**PLEASANT PRAIRIE PLAN COMMISSION MEETING
VILLAGE HALL AUDITORIUM
9915 39th AVENUE
PLEASANT PRAIRIE, WISCONSIN
5:30 P.M.
April 16, 2018**

VILLAGE STAFF REPORT OF APRIL 16, 2018

CONSIDERATION OF A PLAN COMMISSION RESOLUTION #18-08 FOR A COMPREHENSIVE PLAN AMENDMENT

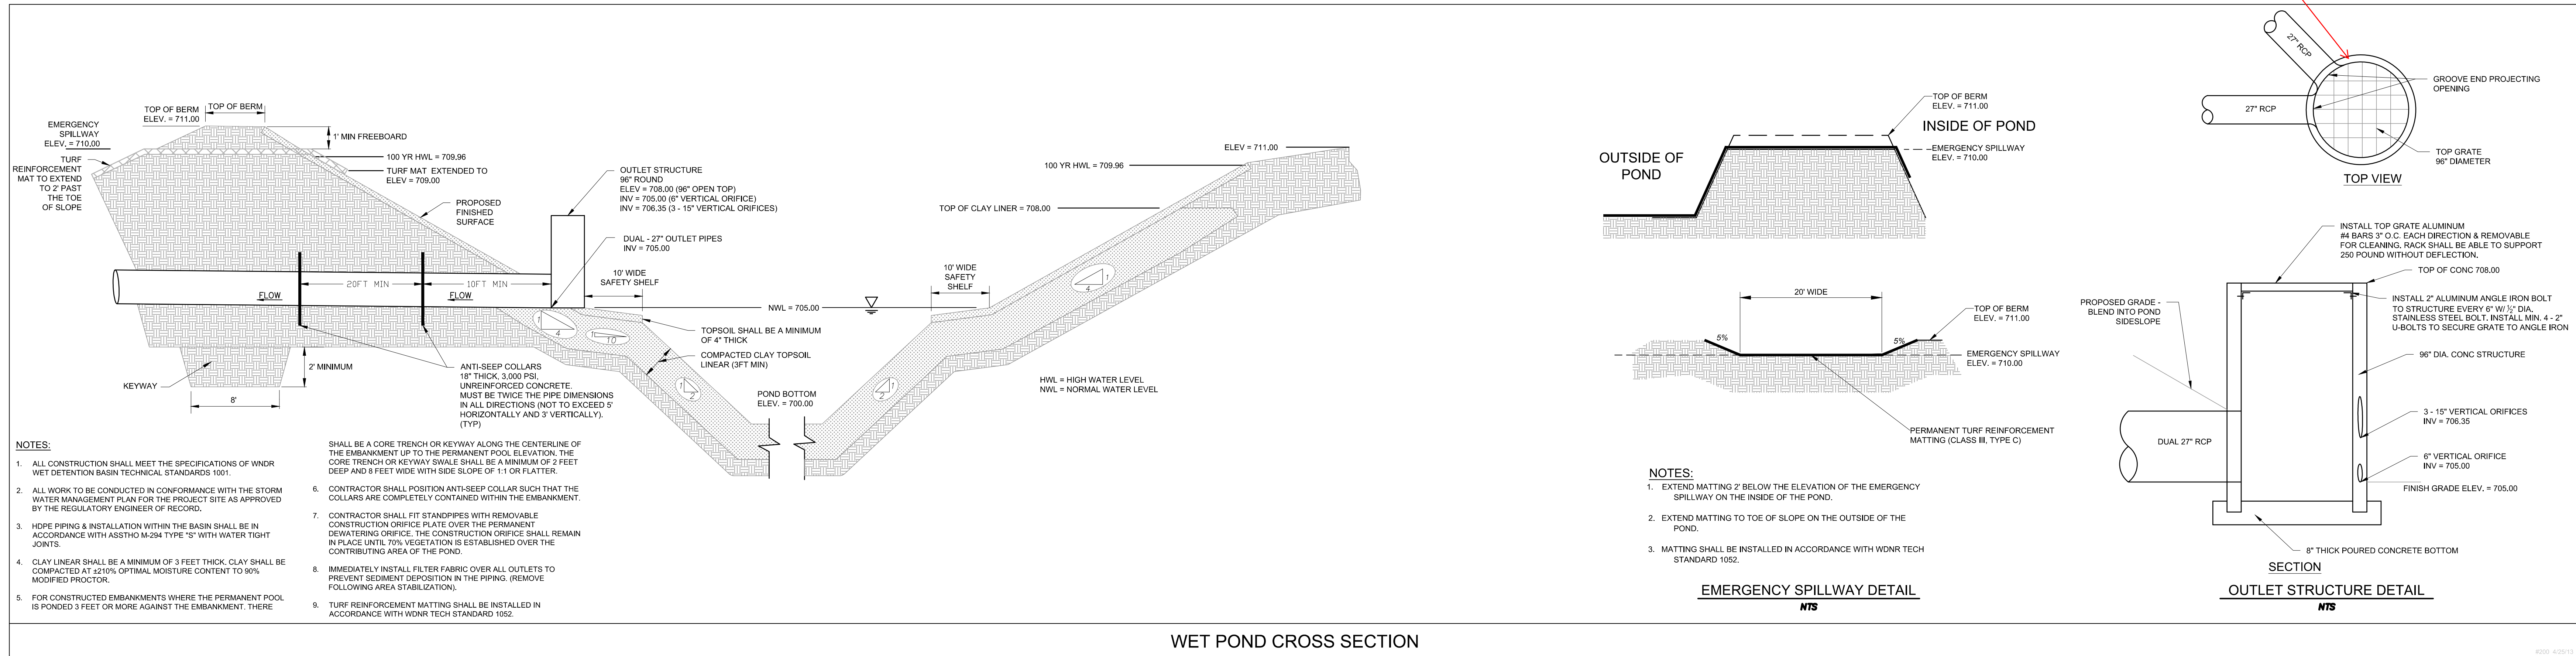
REPLACE DETAIL WITH
CURRENT EDITION-
(REVISED DATE OF
10-30-17

PROVIDE INFORMATION OF
SECTIOND MANHOLE IN
CONFIGURATION. NO ORIFICES OR
OPEN TOP GRATE ON THE OTHER?
VERIFY

SHEET
C-2
OF
C-9

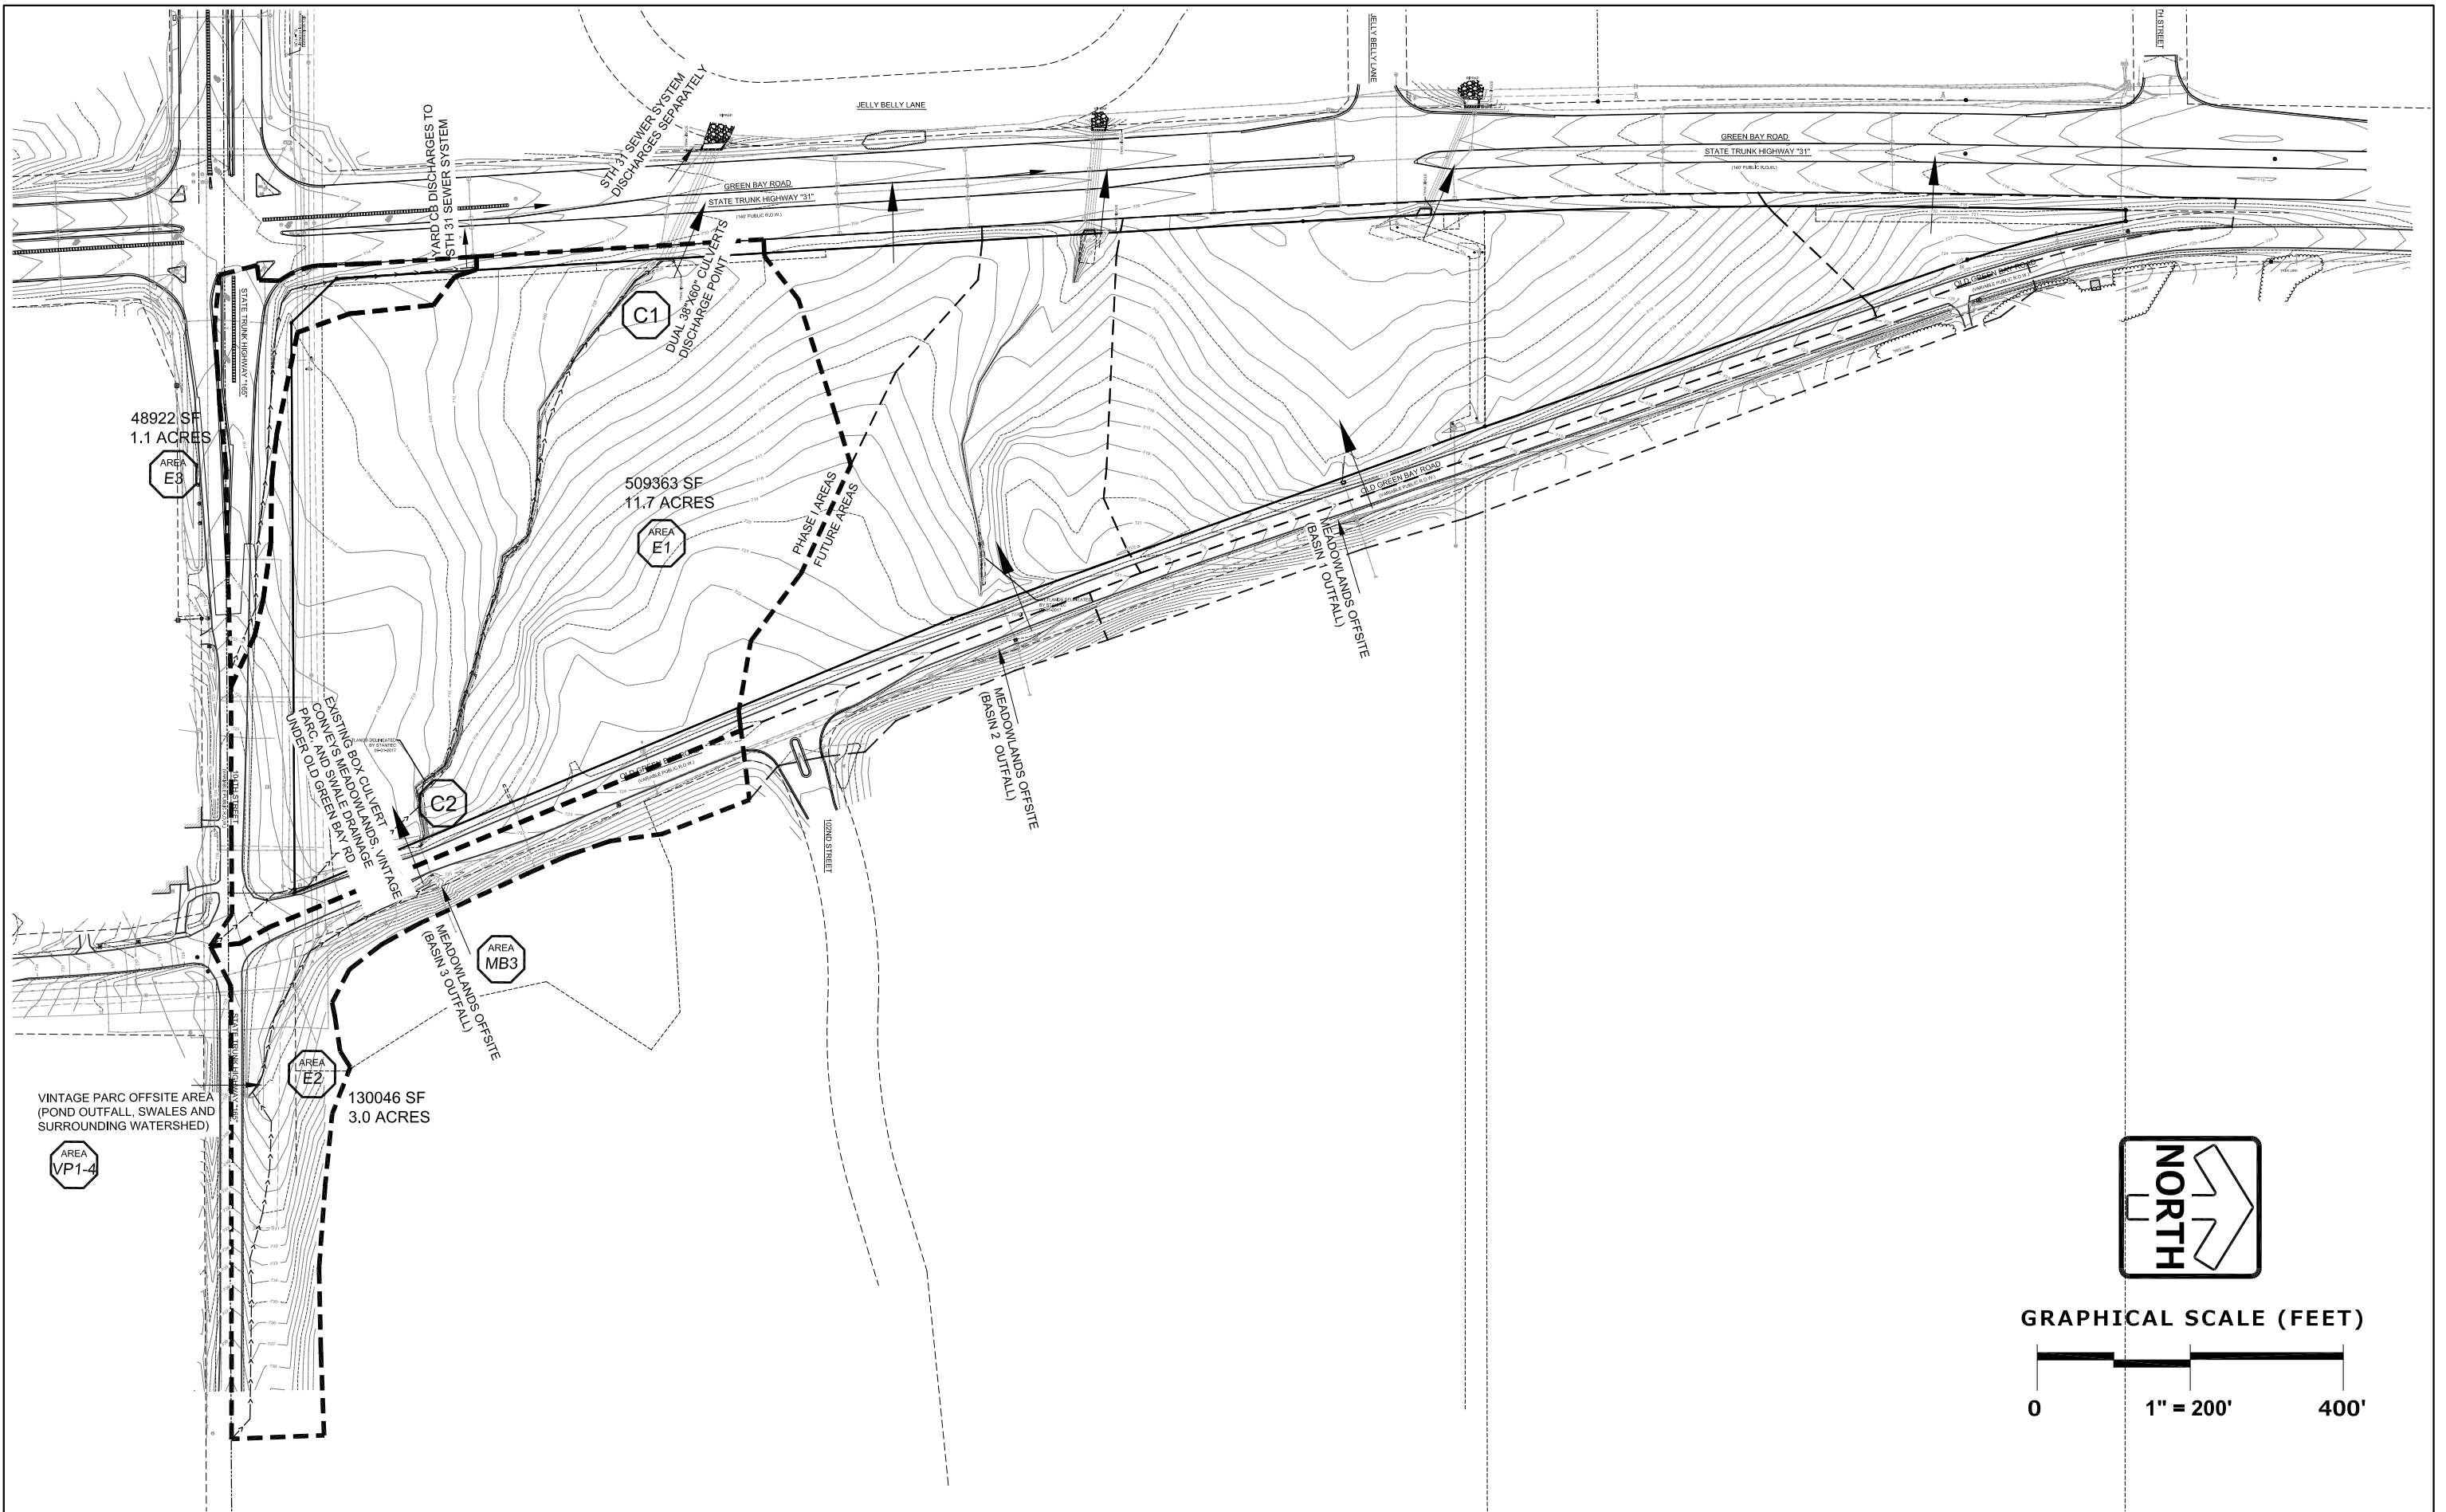
- c. All first phase required public roadway improvements shall be provided.
 - d. On Page C-2, add note to relocate hydrant on east side of road just south of 102nd Street.
